THE CITY OF KEY WEST

ADDENDUM NO. 1  
TO THE CONTRACT DOCUMENTS Project No.: 439197  
for the construction of the

Date: February 18, 2016

**REPAIRS AND IMPROVEMENTS AT ZERO DUVAL AND MALLORY SQUARE**

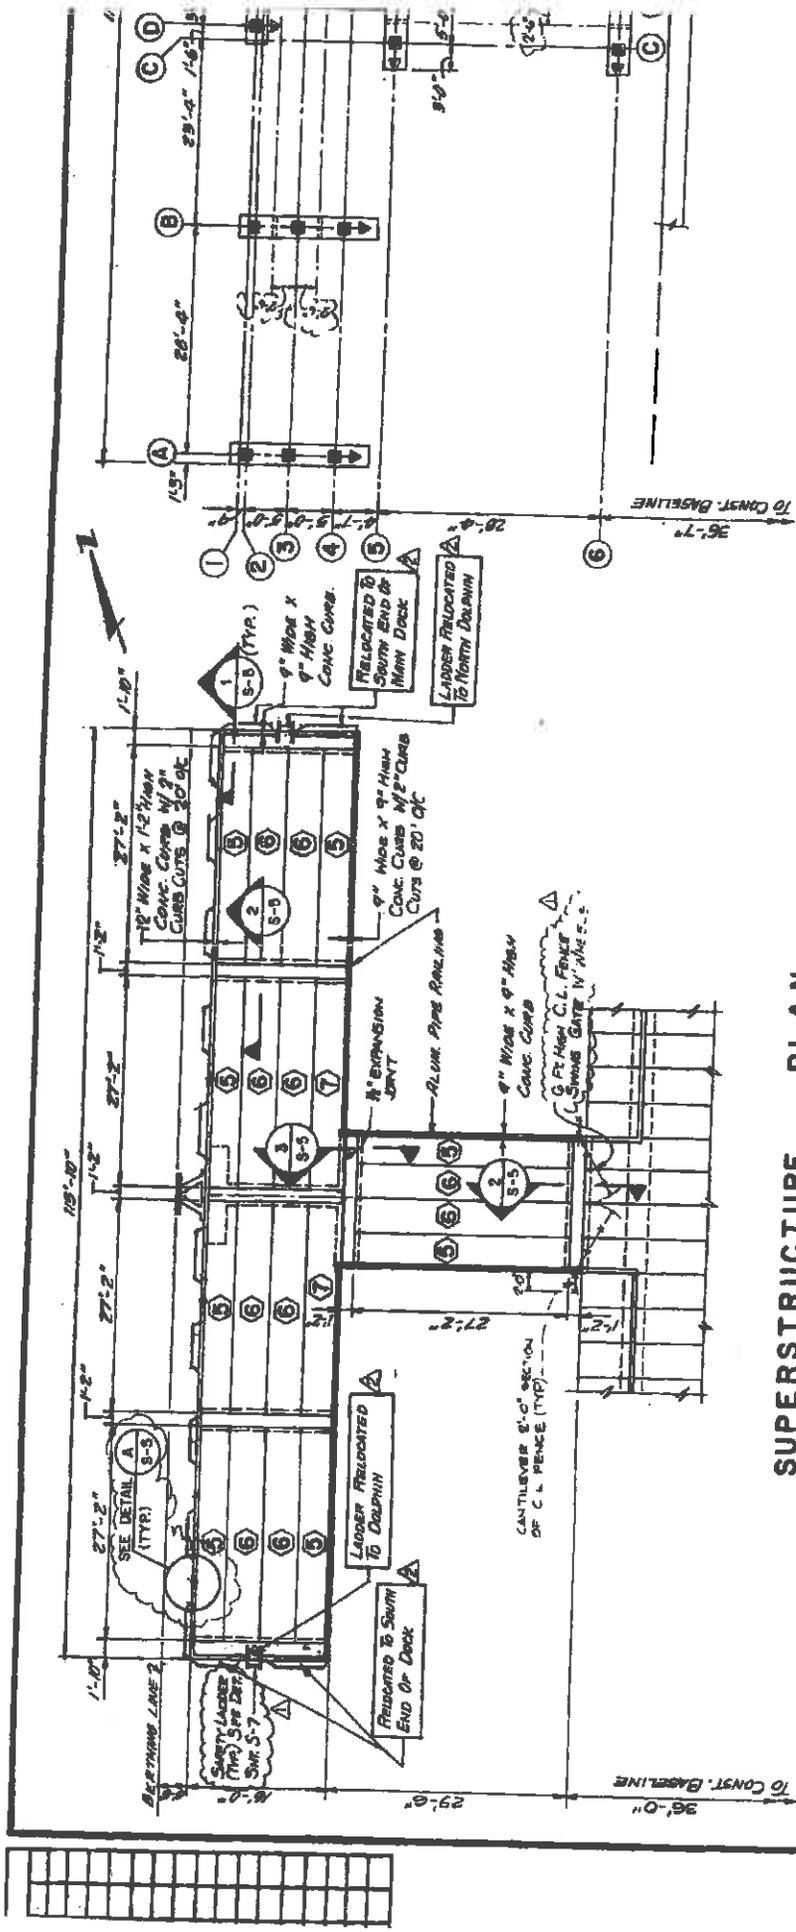
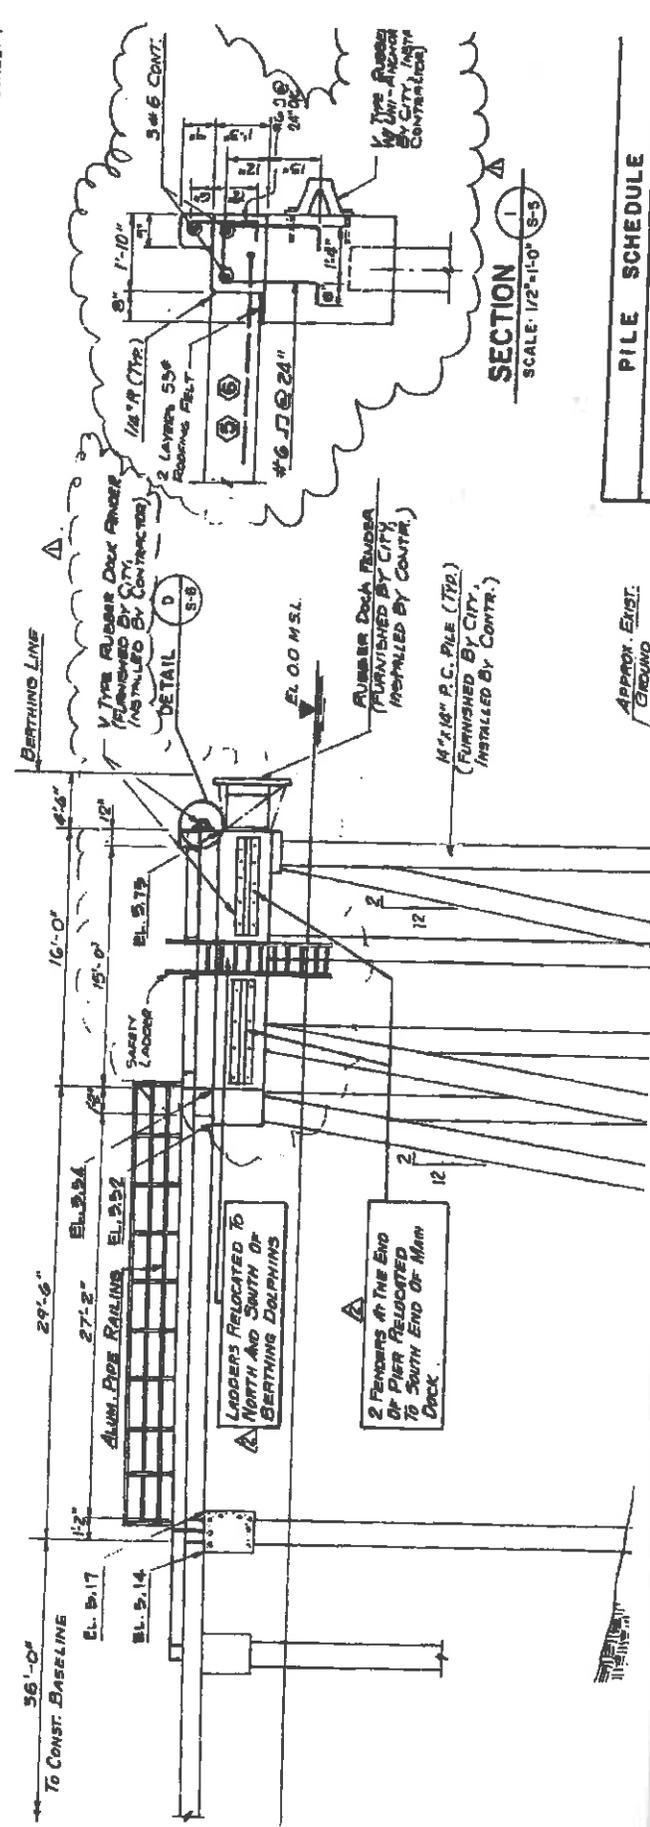
25. Are the original T-Pier drawings available? We are looking for existing pile information.

RESPONSE: Original T-Pier as-built construction drawings dated April 12, 1985 are included with this addendum. Considering 30 years have elapsed since construction, existing conditions may vary from those depicted in the drawings.
